**Report to  
Development Permit Panel**

**Date:** October 31, 2006

**File:** DP 06-345111

**Re:** **Application by S-8117 Holdings Ltd. for a Development Permit at  
10171 No. 1 Road**

LOT COVERAGE 41%  
BY VARIANCE

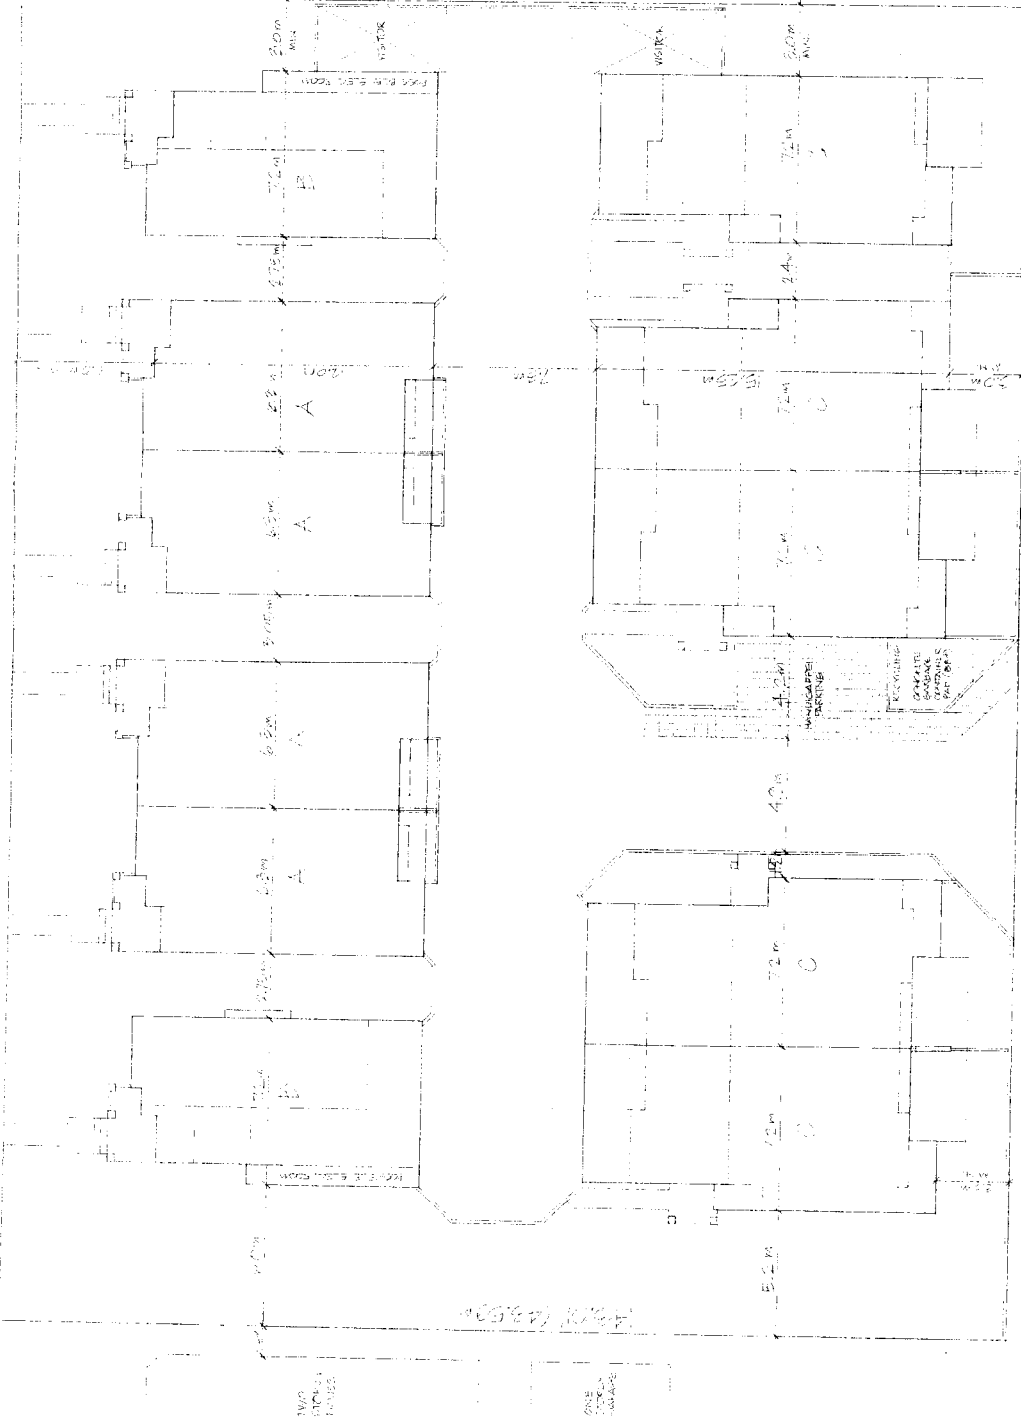
The applicant requests to vary the provisions of the Zoning and Development Bylaw No. 5300 to increase the maximum permitted lot coverage from 40% to 41%.

*(Staff supports the proposed variance as it is a direct result of incorporating larger front porches fronting onto No. 1 Road as requested by the Advisory Design Panel and supported by staff. The pedestrian-oriented porches animate the streetscape. The variance was noted during the rezoning process and no concerns were raised at the Public Hearing).*

PLAN# A

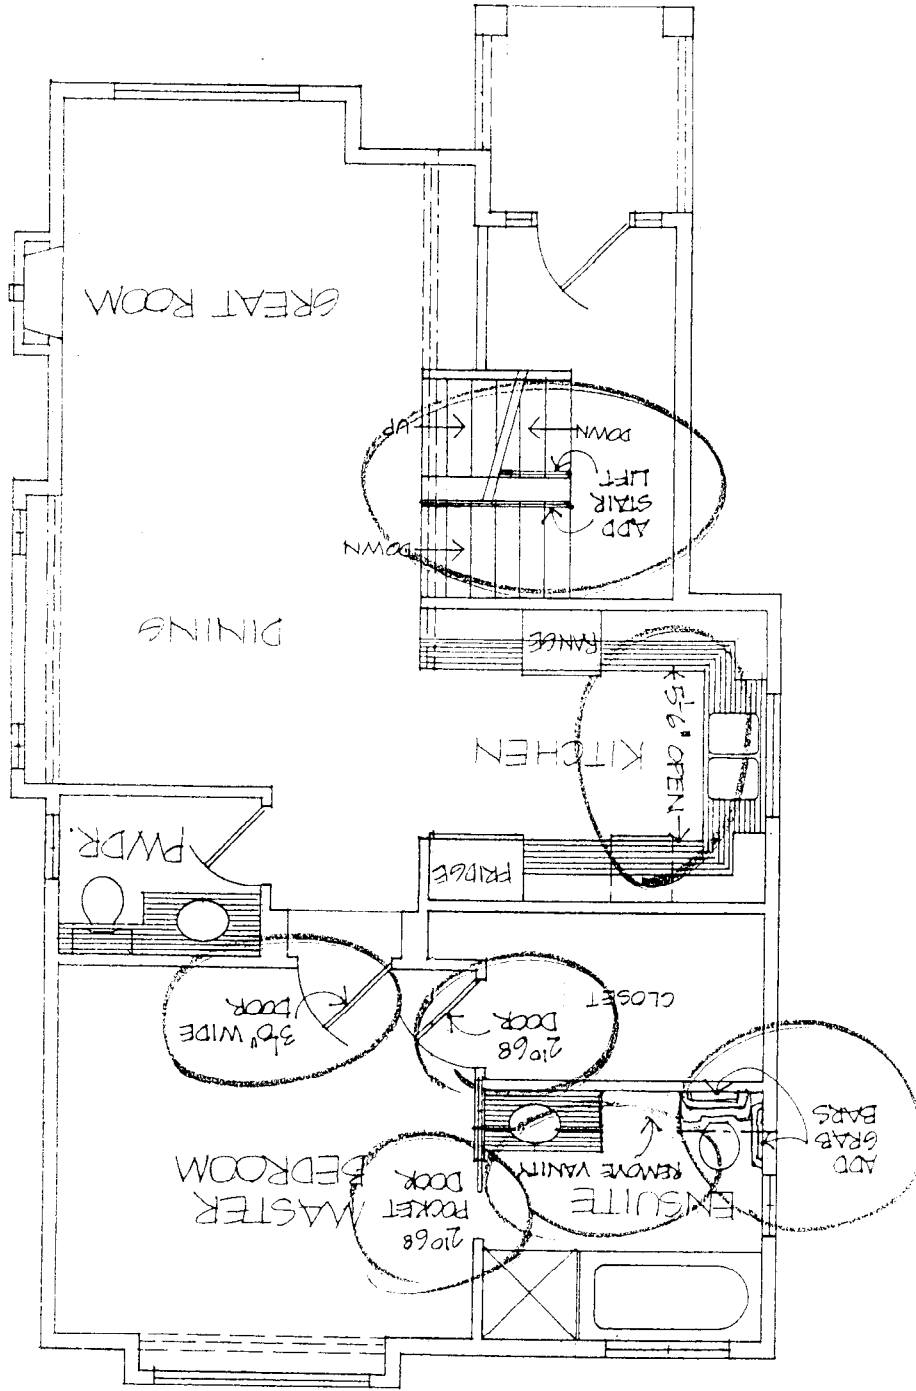
- The applicant has demonstrated a sensitive transition to the adjacent single-family homes to the north and west;
- The No. 1 Road streetscape is animated with pedestrian-oriented front entries and a communal pedestrian entry to the development (**Reference Plan A**);

REFERENCE  
PLAN # B NOV 29 2006  
DP 06345111

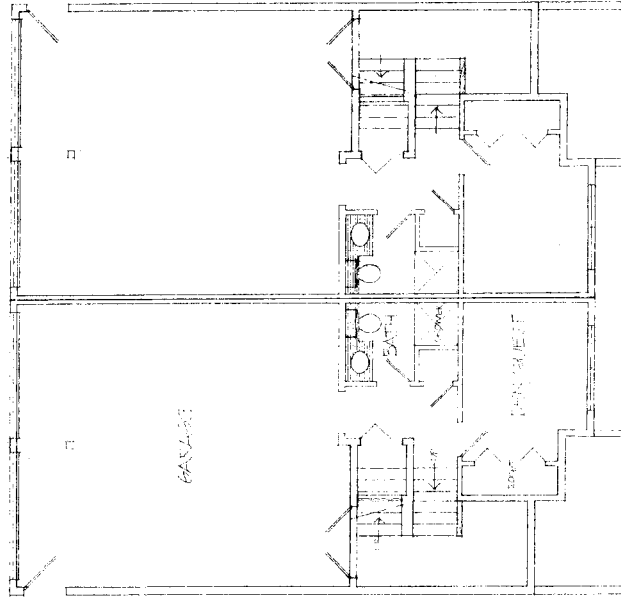
- An accessible unit has not been provided in this 11-unit development. An alternate floor plan demonstrating conversion potential to accommodate a person in a wheelchair is provided for the two (2) detached units with the installation of a chair lift (**Reference Plan B**).
